**SEDGWICK COUNTY HISTORIC COURTHOUSE
FOUR CORNER TOWERS RE-ROOF WORK
510 NORTH MAIN
WICHITA, KANSAS
PROJECT #04-0073**

ADDENDUM NO. 1

October 1, 2004

1 TYPICAL WORK REQUIREMENT OF METAL AT ALL TOWERS

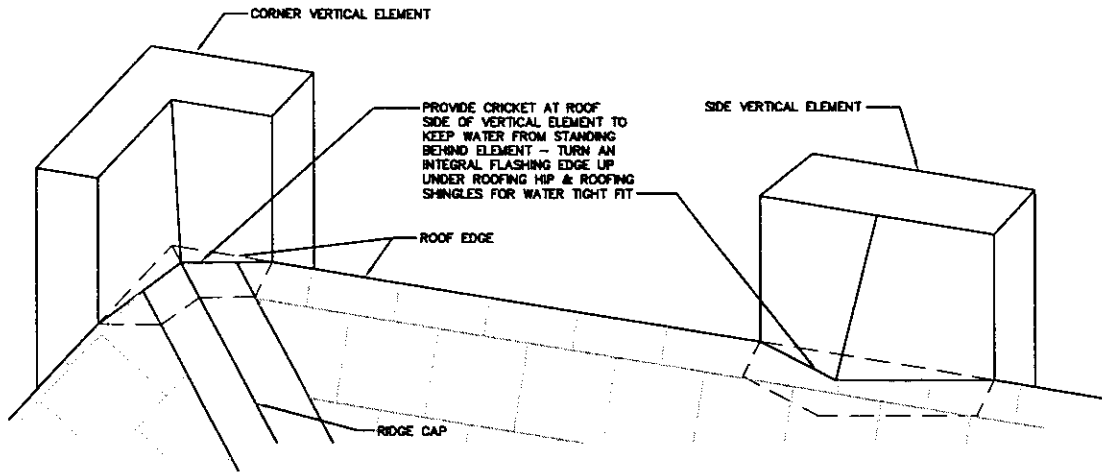
- a. **Provide a cricket on the back side of the vertical elements surrounding the roof edges of each of the towers per the attached drawing titled "1 – CRICKET DETAIL AT VERTICAL ELEMENTS".**
- b. **See attached clarification drawing titled "1 – TYPICAL WORK REQUIREMENT OF METAL AT ALL TOWERS" for requirement of metal to be replaced or refurbished.**

REPLACE ALL METAL FROM TURNED
DOWN EDGE TO TOP OF PINNACLE

REWORK OR REPLACE THIS MET
AS REQ'D FOR NEW APPEARANC

ALL METAL ABOVE THE DENTALS AS INDICATED IN THIS PHOTO IS TO BE REPLACED WITH NEW METAL OF EQUAL ORIGINAL GAUGE WITH FACTORY APPLIED KYNAR PAINT TO MATCH THE EXISTING COLOR. METAL IS TO MATCH THE HISTORIC EXISTING PROFILES.

METAL FROM THE TOP OF THE DENTALS DOWN (UNDER THE OVERHANGING CORNICE) AS INDICATED IN THIS PHOTO IS TO BE REWORKED IF POSSIBLE PER THE SPECS. IF THE MATERIAL IS DETRIORATED TO A POINT WHERE IT IS NO LONGER SERVICABLE IT IS TO BE REPLACED IN THE SAME MANNER AS THE MATERIAL ABOVE WITH METAL MATCHING COLOR AND CONFIGURATION OF HISTORIC PROFILE.
